Application for an amendment to a clearing permit

Environmental Protection Act 1986 s 51M

Siemens Gamesa Renewable Energy Pty Ltd
(ABN 90 614 784 575)

Part 5 Proposed changes

WTG08

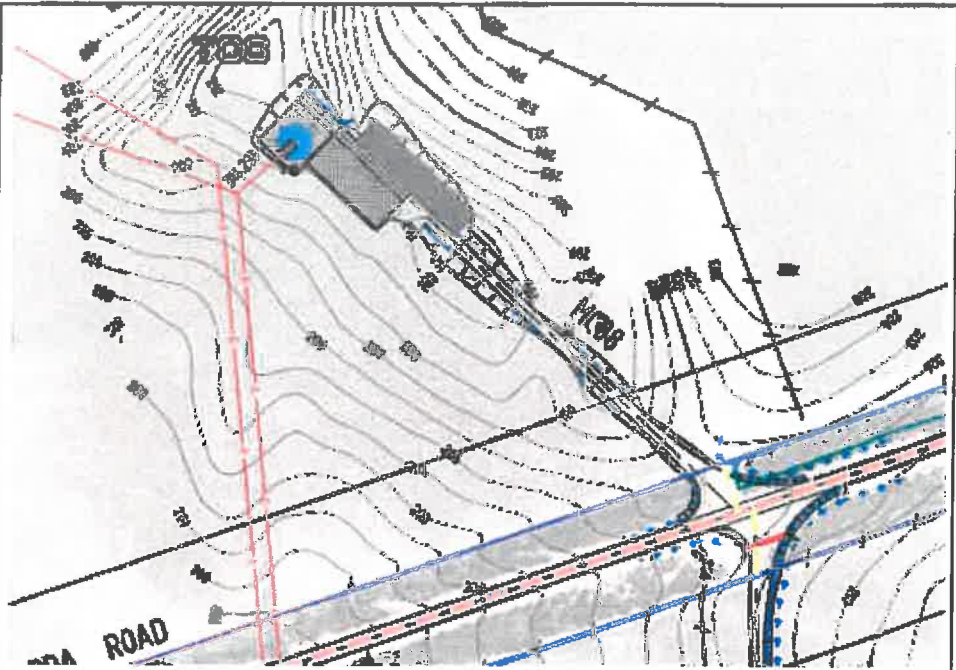
Entrance to T08 - this location has changed from the alignment on the clearing permit, as was not designated as native veg on the shapefiles. Shapefiles provided do not detail this as native veg, but majority of road reserve down Cadda would be classified as native veg. The access road entrance to this location now is at existing gate location, previously cleared, so has reduced the amount of veg clearing required.

WTG37

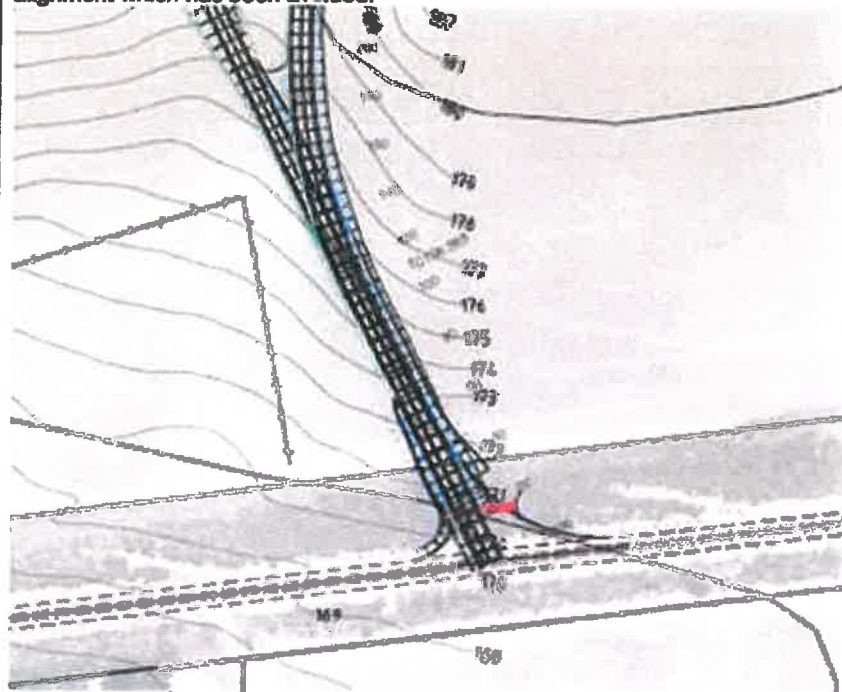
Entrance to T37 – this location has changed from the alignment on the clearing permit, as was not designated as native veg on the shapefiles for initial design. Shapefiles provided do not detail this as native veg, but majority of road reserve down Cadda would be classified as native veg. The access road entrance was repositioned due to design requirements for transportation access, which has resulted in reduction clearing of the road verge. In addition the Landowner has a specifically fenced area on the originally design access road alignment which has been avoided.

Bibby Creek – Access Road to WTG01/02/03

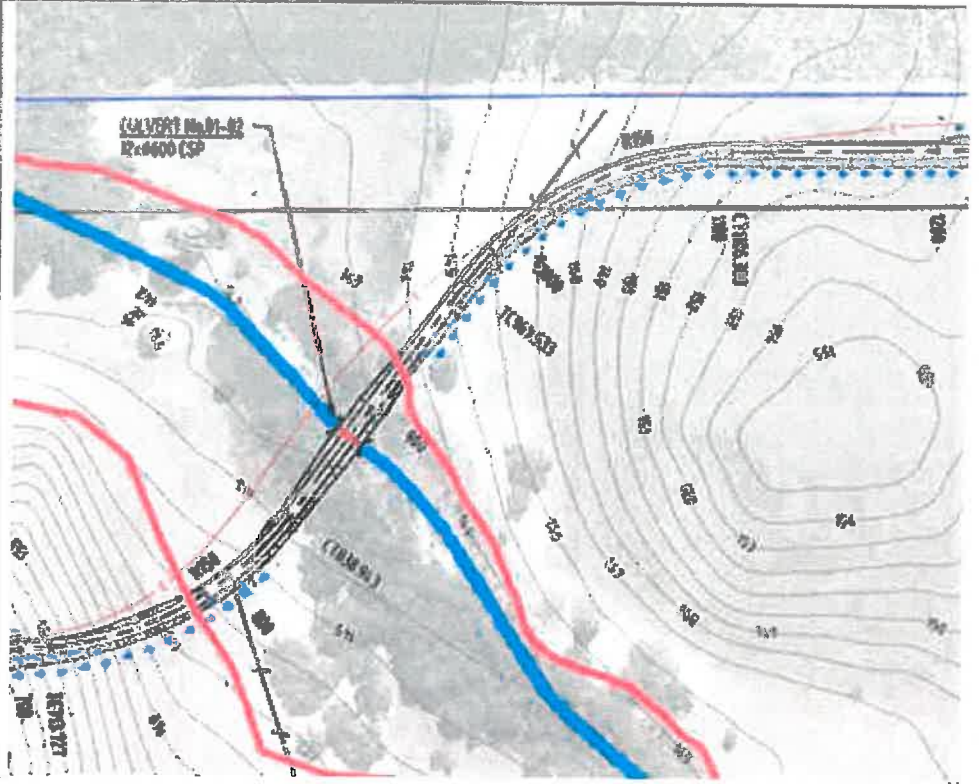
The change to the alignment for the access road to WTG01/02/03 v's clearing permit route this location has changed from the alignment on the clearing permit, as it was not designated as native veg on the shapefiles at initial design. The alignment change was borne from Cultural heritage requirement of preferred creek crossing alignment. This also allow the clearing to be minimised by placing the electrical cable and access road in closer proximity.

In addition the redesign route minimises impact to the Landowner's arable land by positioning the cable and road along the boundary fenceline, reduces excessive works to construct access road within specifications and reduce need for additional vegetation clearing.
